## PLANNING COMMISSION MEETING STAFF REPORT

**NAME OF PROJECT:** Midway Springs

**AGENDA ITEM:** Midway Springs Preliminary Approval (standard subdivision area of development)

**Subject: Midway Springs, Preliminary and Master Plan Approval**

WATTS ENTERPRISES  
MIDWAY SPRINGS  
PRELIMINARY  
LANDSCAPE PLAN

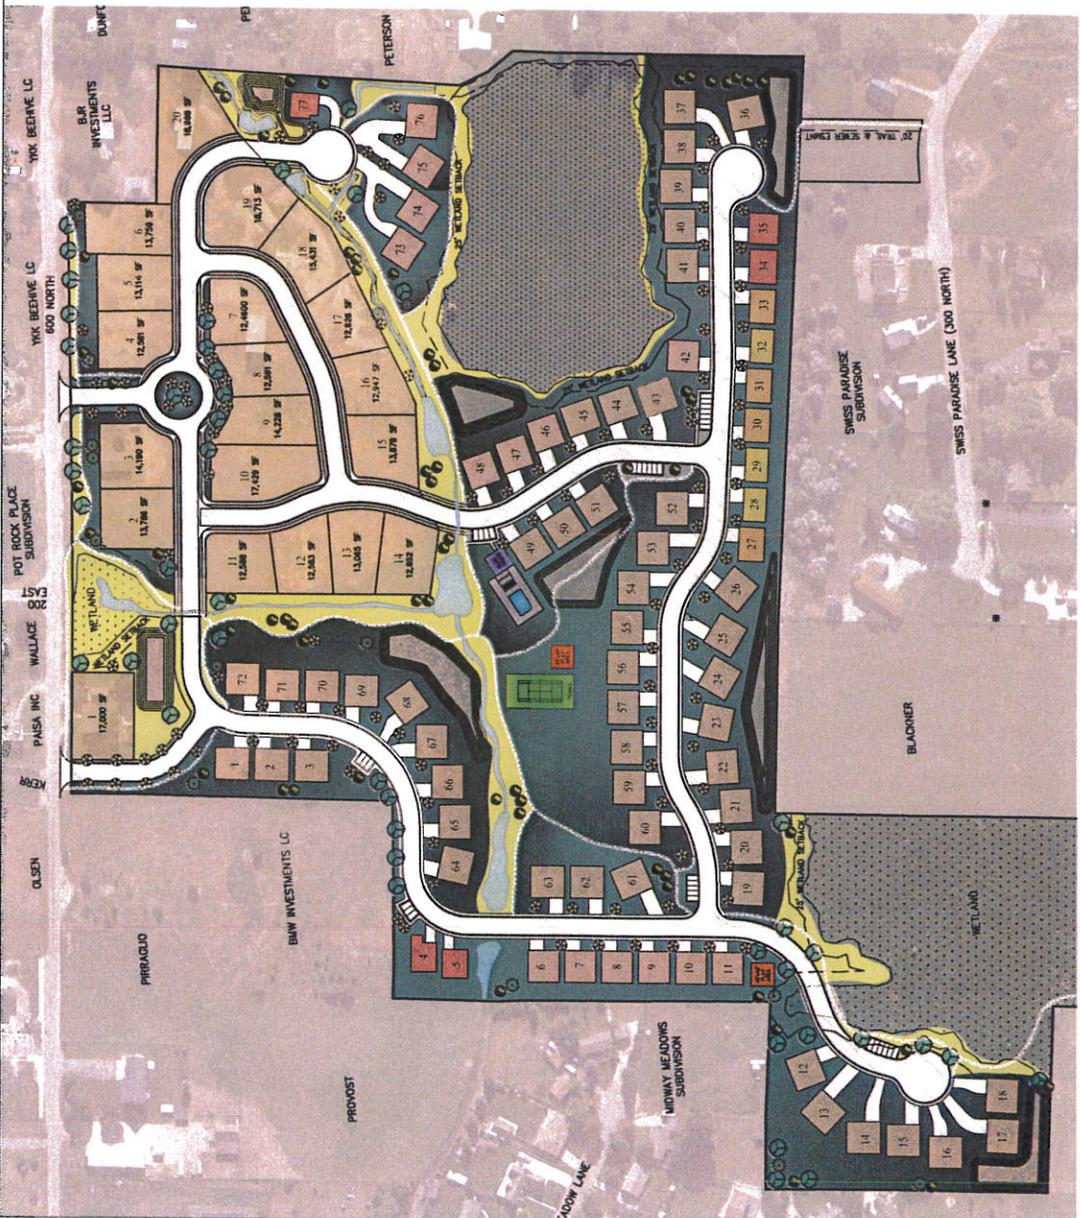
- Adjacent to 600 North and along the stream corridors and wetlands the landscaping plan shows a native grass mix. The irrigation system and mowing schedule should be discussed. Are there any maintenance plans for the wetlands?
